FIELD VARIANCE FORM

DATE: 27-SEPT-2012	PROJECT NAME: Future East Garrison Munitions Response Area	PROJECT LOCATION: Future East Garrison	
APPLICABLE DOCUMENT / SECTION:	Final Group 4 Remedial Investigation/Feasibility Study Work Plan, Volume 2 – Sampling and Analysis Plan, Appendix G Explosives Siting Plan		
SUBJECT:	<u>Appendix G; Update of Explosives Siting Plan to include updated minimum separation distance for 37mm projectile and addition of maximum fragmentation distance for soil sifting operations.</u>

FVF No. G4WP-004

Figure 3 (Rev 1)

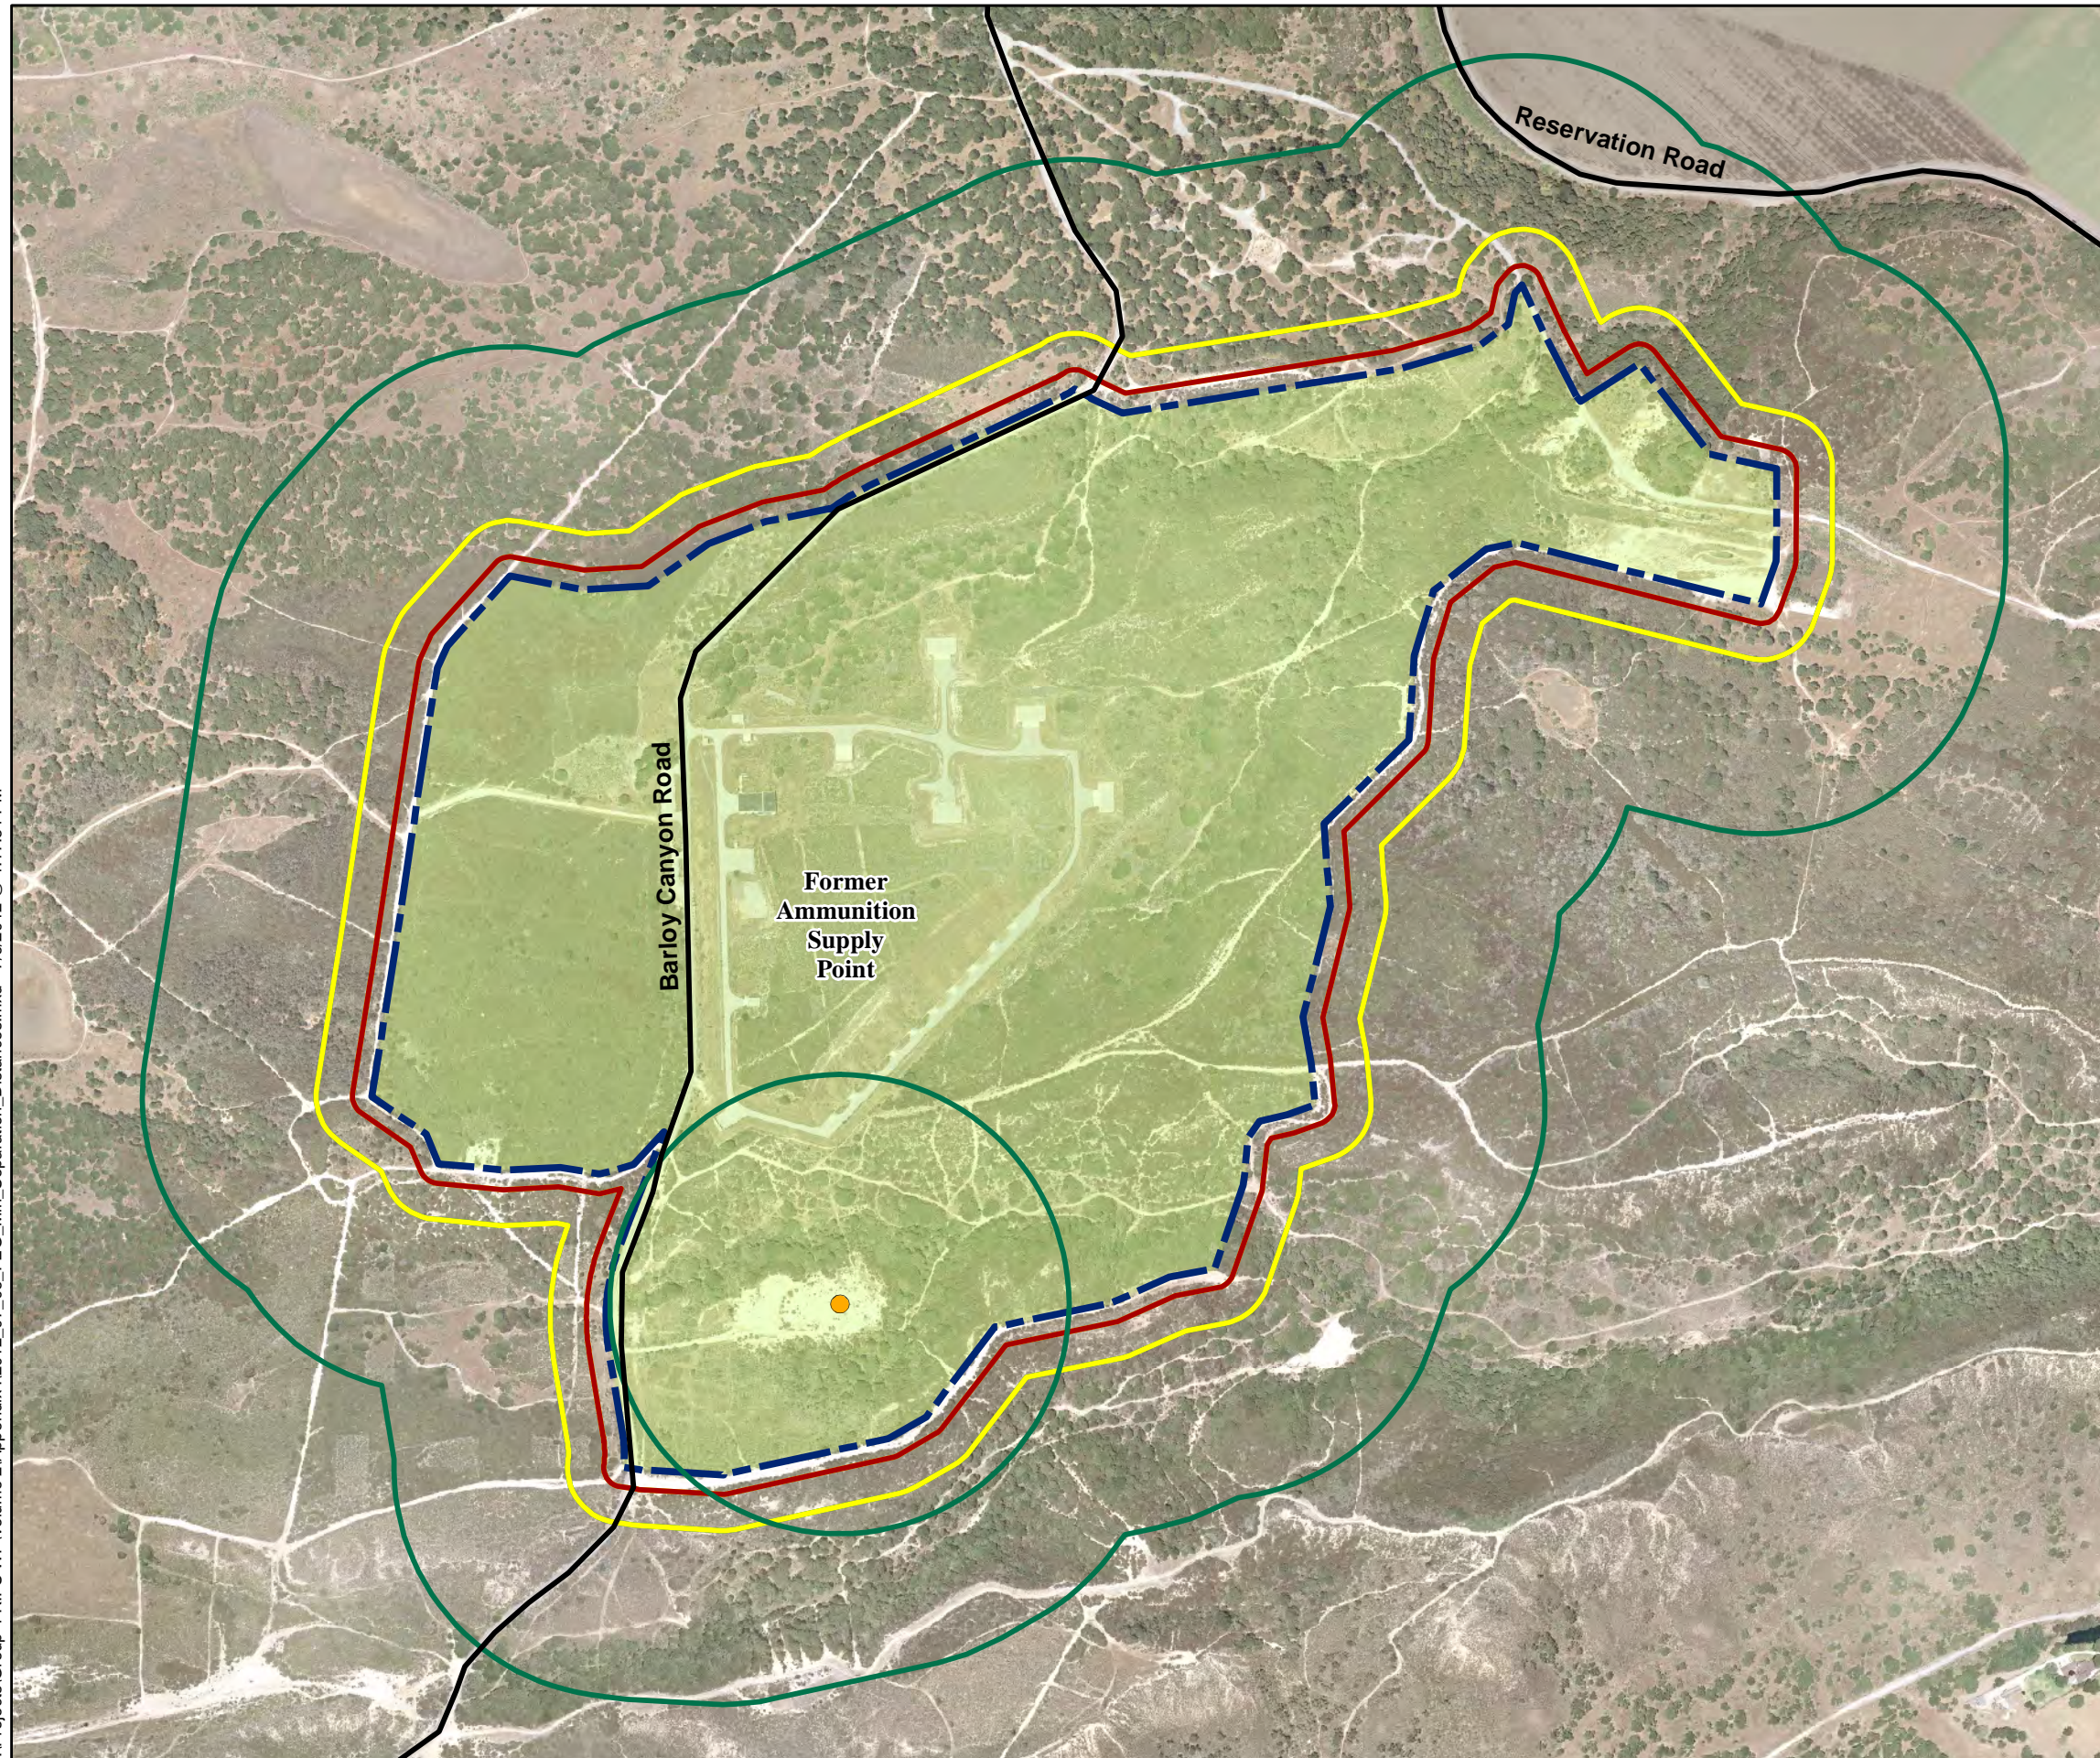
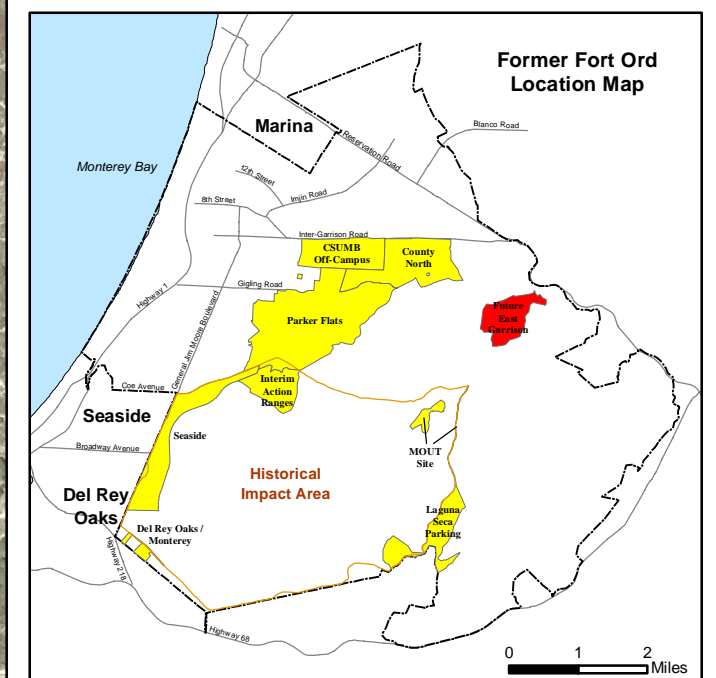
- Addition of Section 1.2, Soil Sifting Operations, to include operations for the field activities associated with the soil sifting operations such as placement of equipment, transport of soil, and quality assurance procedures.
- Increased maximum fragmentation distance (MFD) for intentional detonations for the 37mm MK I, LE projectile from 816 ft to 824 ft (Section 1.5.1 [previously Section 1.4.1], Table 1, Figure 3 [Rev 1], and Figure 7 [Rev 1]).
- Increased hazardous fragment distance (HFD) MSD for nonessential personnel for unintentional detonation for the 37mm MK I, LE projectile from 68 ft to 70 ft (Section 1.5.2 [previously Section 1.4.2], Table 1, Figure 3 [Rev 1], and Figure 7 [Rev 1]).

-  Hazardous Fragmentation Distance of 70 Feet for Projectile, 37mm, LE MK I
-  Minimum Separation Distance of 200 Feet for Sandbagged Detonations
-  Maximum Fragmentation Distance of 824 Feet for Projectile, 37mm, LE MK I
